**SOIL/SITE EVALUATION
 for ON-SITE WASTEWATER SYSTEM**

SITE PLAN APPROVAL

Show profile locations and other site features (dimensions, reference or benchmark, and North).

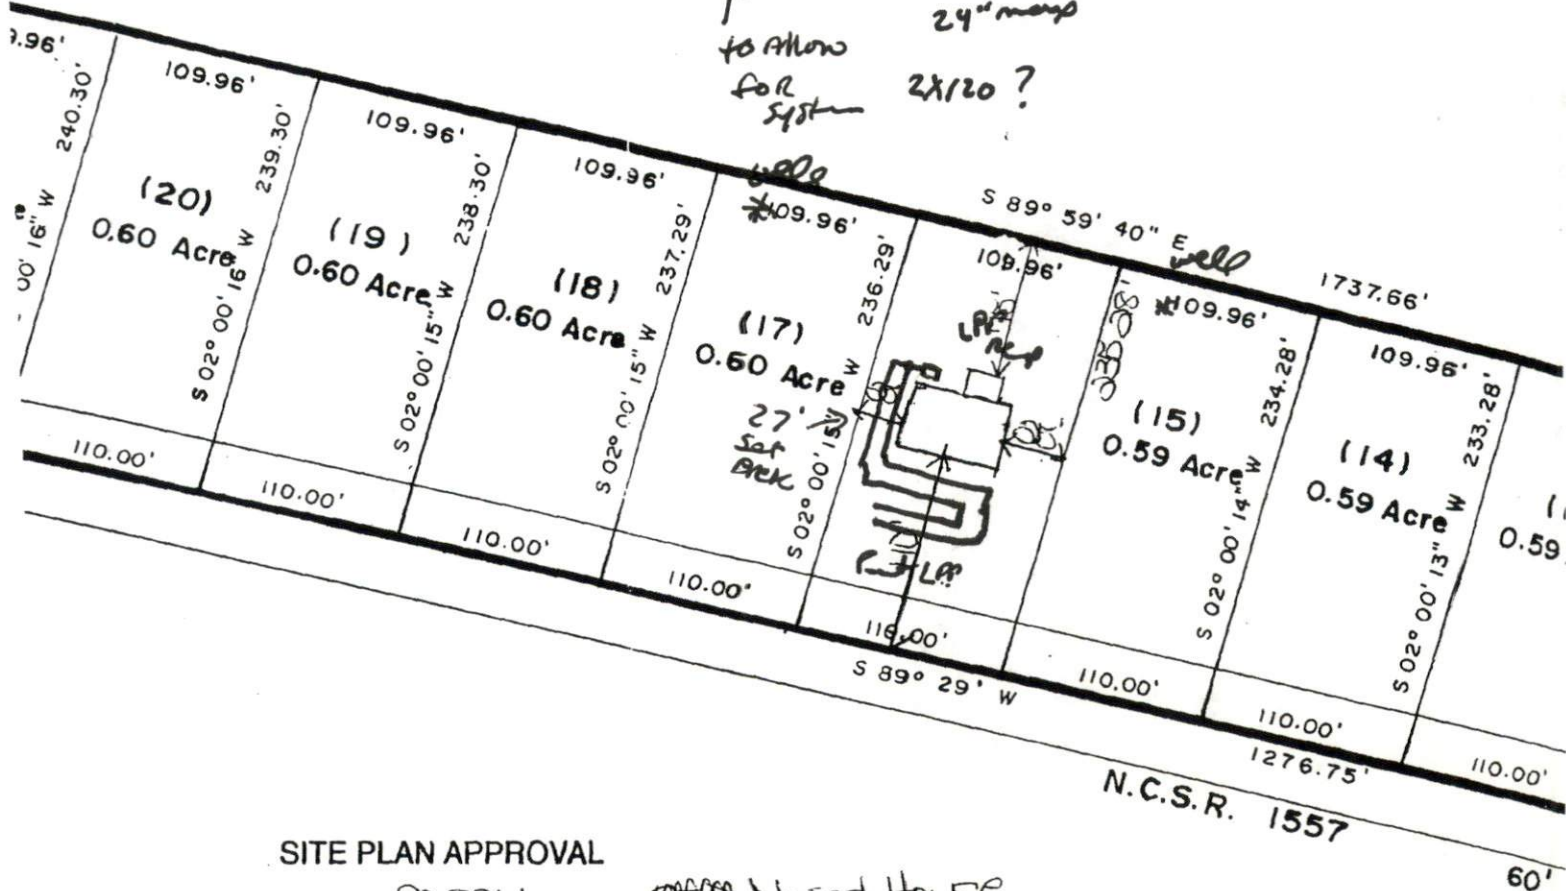
* NEEDS ^{* CO.F.T} correct moving over # for distance front, 1' to allow for system 24" manp 2x120?
